Released Engineering Change Note

REC N 2673 XB-10

USB PCB 004-324 AG8210_2.

Picture of affected area.

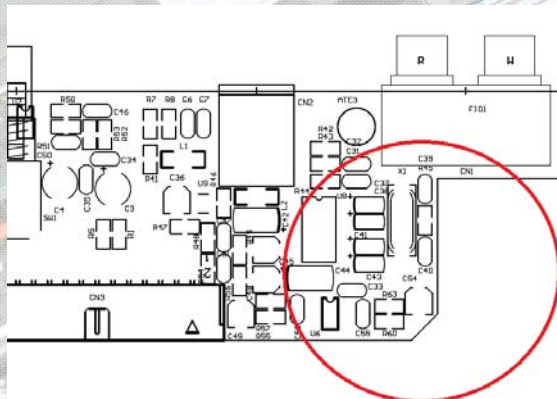
Change shape and move components.
Corner radiused. Moved C39, C40, C54, R45, X1

Prevent contact with harness.

No change to parts or circuitry.
